ORDER UNDER SECTION 96 (2) OF ACT, III OF 1901.

Mr. Baola K. Luma is informed that the plan submitted by him for building a chawl on plot No. 2A/2 Survey Sheet S.4 situate in Street, Garden

AMENDED PLAN OF PROPOSED CHAWL
TO BE BUILT ON SURVEY NO 2A
SHEET 1-14 GARDEN Q R

PLAN SHOWING PROPOSED CHAWL TO BE BUILT ON PLOT NO. 2A/2
SHEET 14, GARDEN QUARTERS
SCALE 8"=1'

DRAWING NO. 25

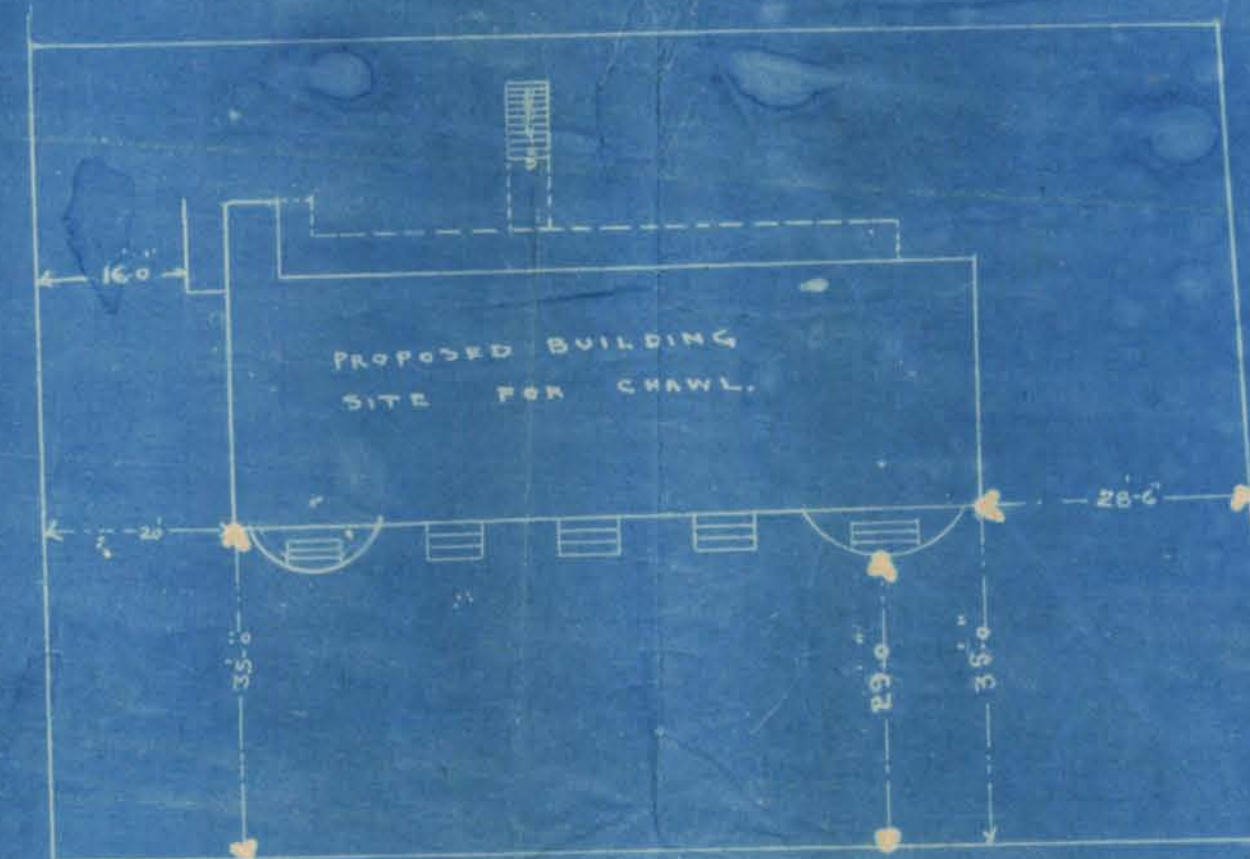
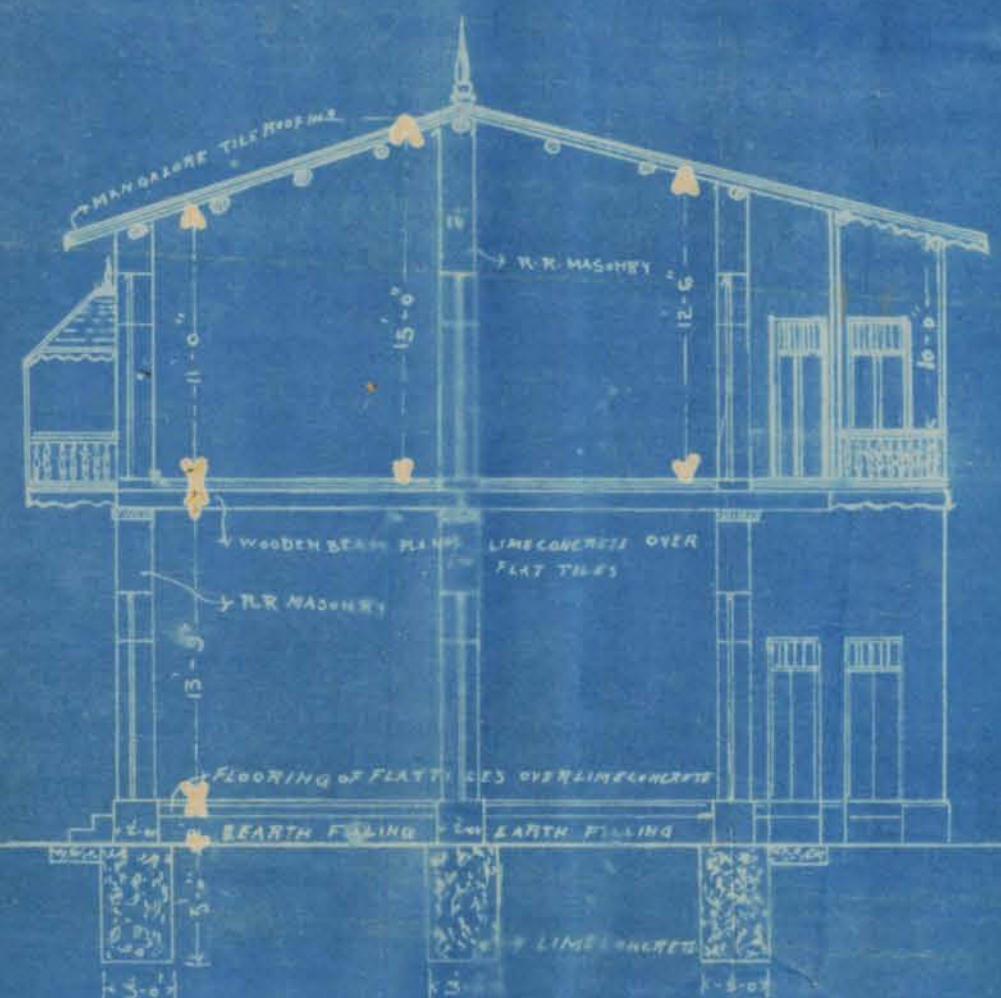
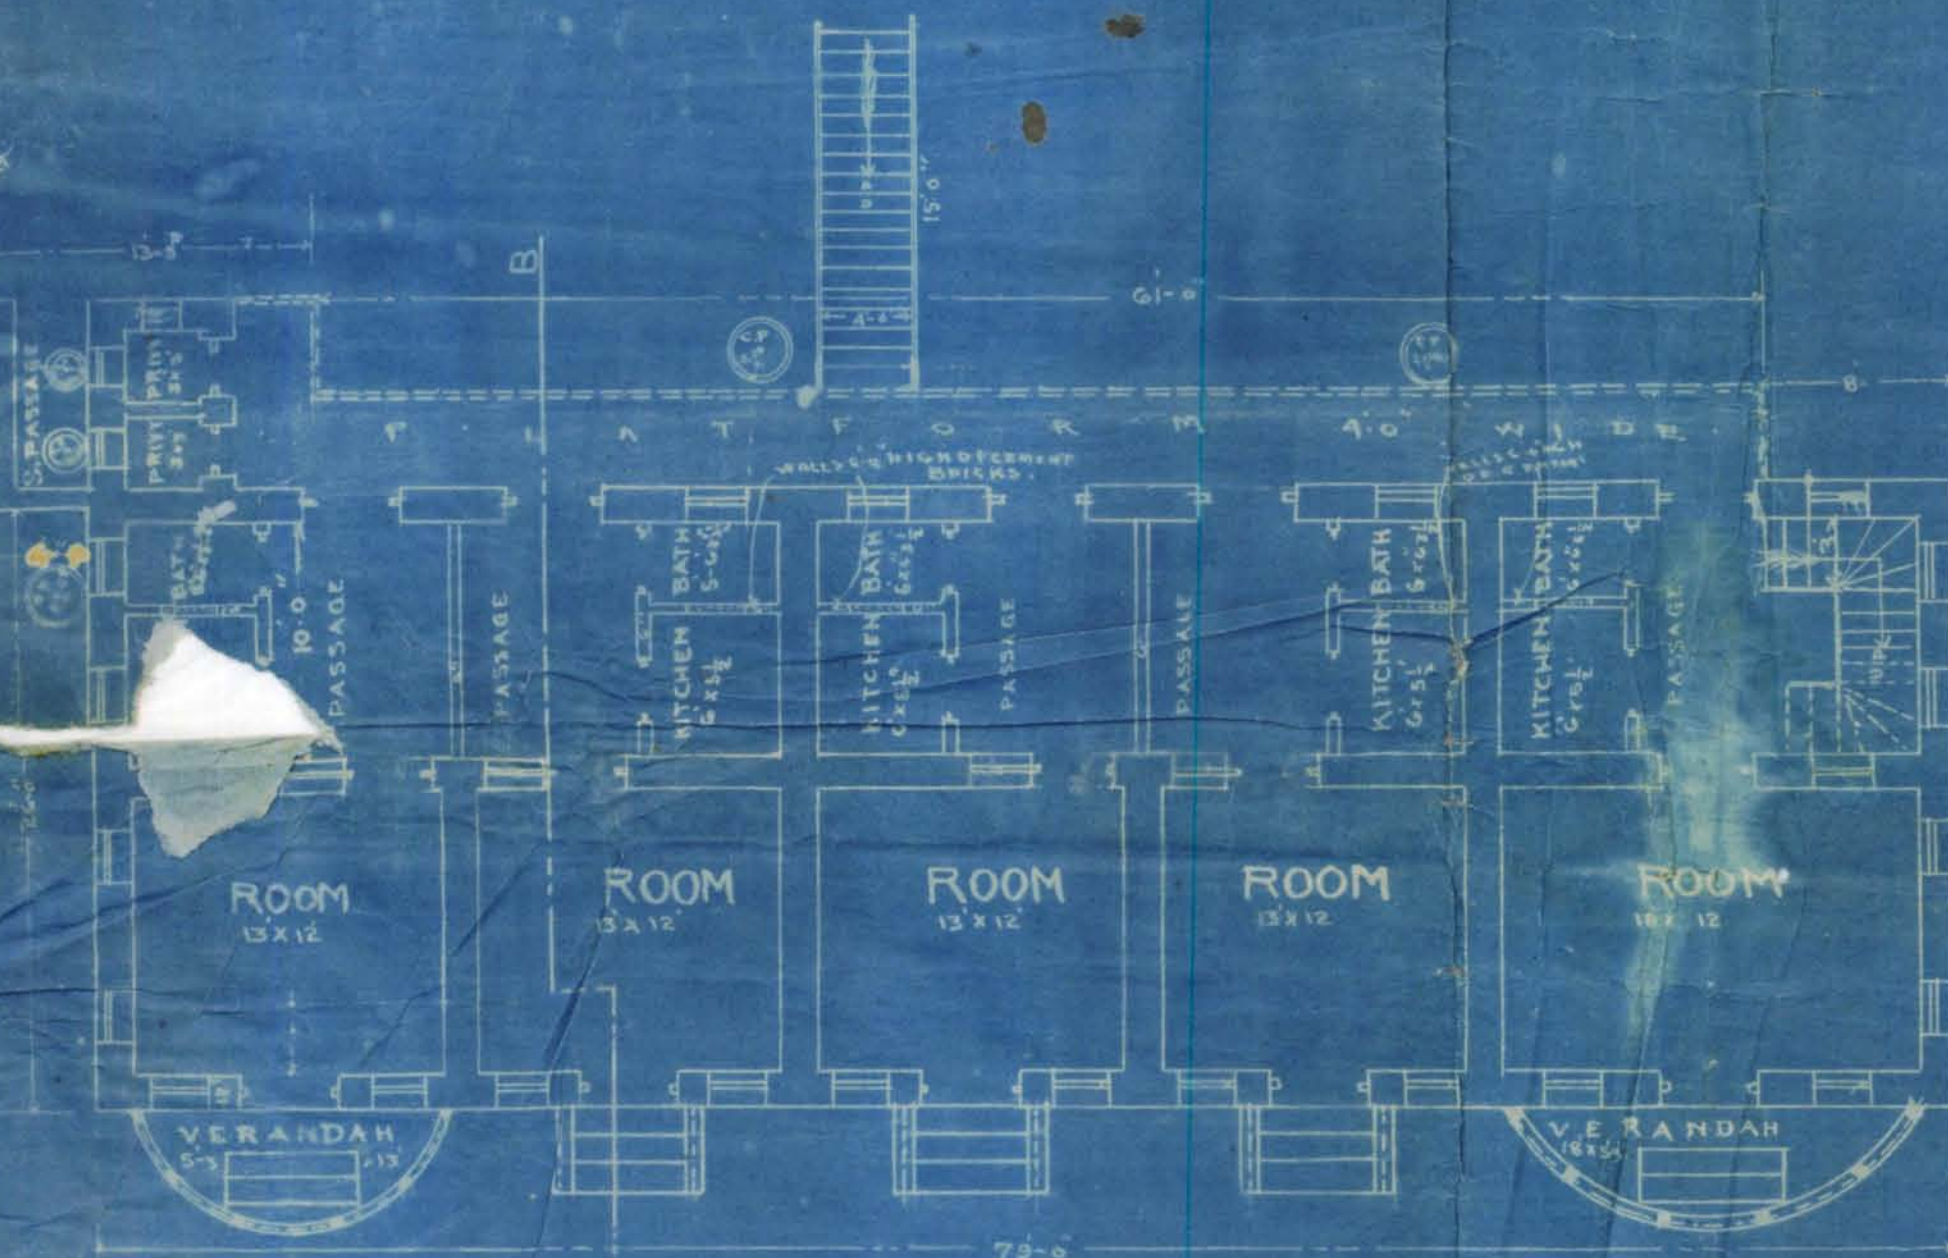
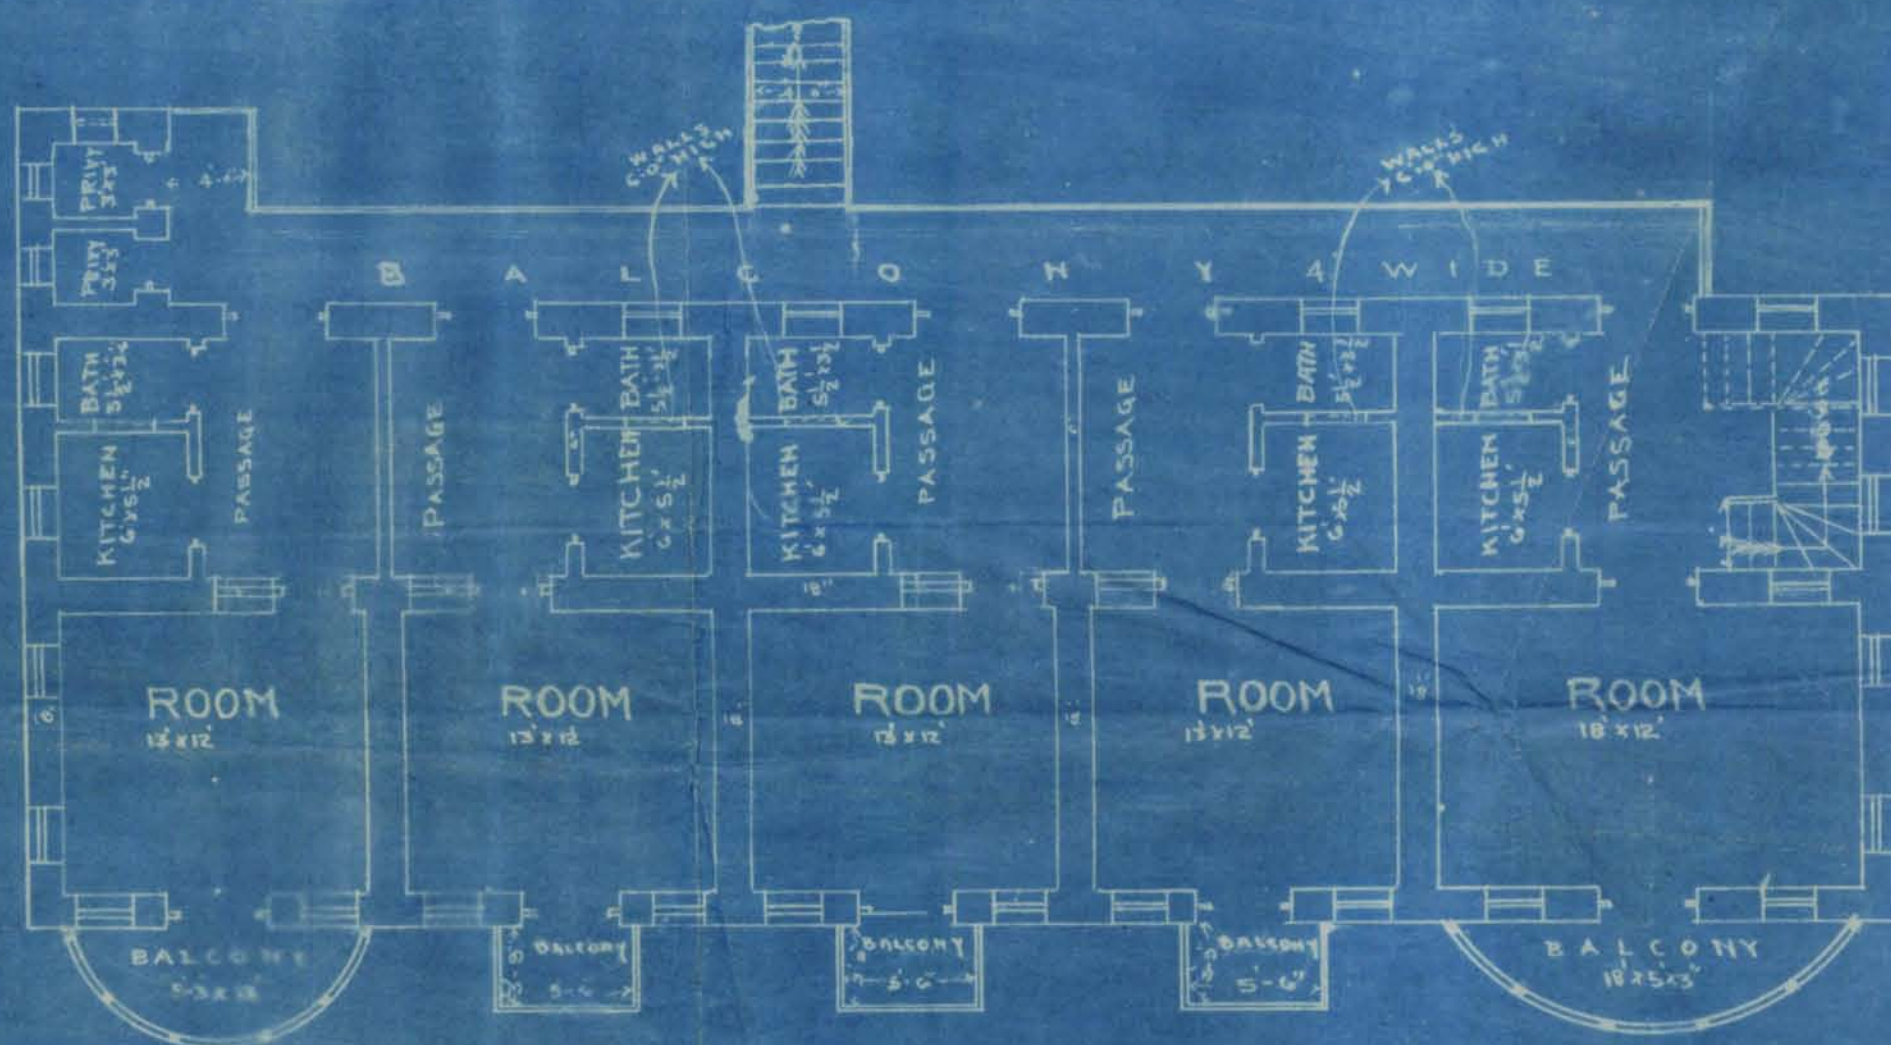
With reference to his letter dated 11th August 1920 with an amended plan for the building under construction on plot No. 2A/2, I-14 Garden Quarter Mr. Bhoola Khima is informed, one room tenement cannot be allowed in that quarter.

With ref: to his letter dated 11th
Aug 20, with an amended plan for
the building under construction on
plot No. 2A/2 I/14 Garden Qu.,
Mr. Bhoolu Khurana is informed.
one room tenement cannot be
allowed in that Garden Qu.
The plan is returned herewith
disapproved

Submitted with the approved
plan & report it is approved
a chawl consisting of 2
room tenements & since the
A.O. object the plan may
be returned & disapproved.
~~The proposed semi circular~~
~~tenements~~

Upon applicant
that one room
tenement cannot
be allowed in that
quarter. The plan
is return disapproved

In compliance with your
memo no 5287 dated 8th Sept
1920 I herewith submit to
you a set of plan ^{no 22 dated 9-19} amended
and making two room tenement
according to your suggestion. I
hope now you will kindly re-
approve my plans at an
early date!
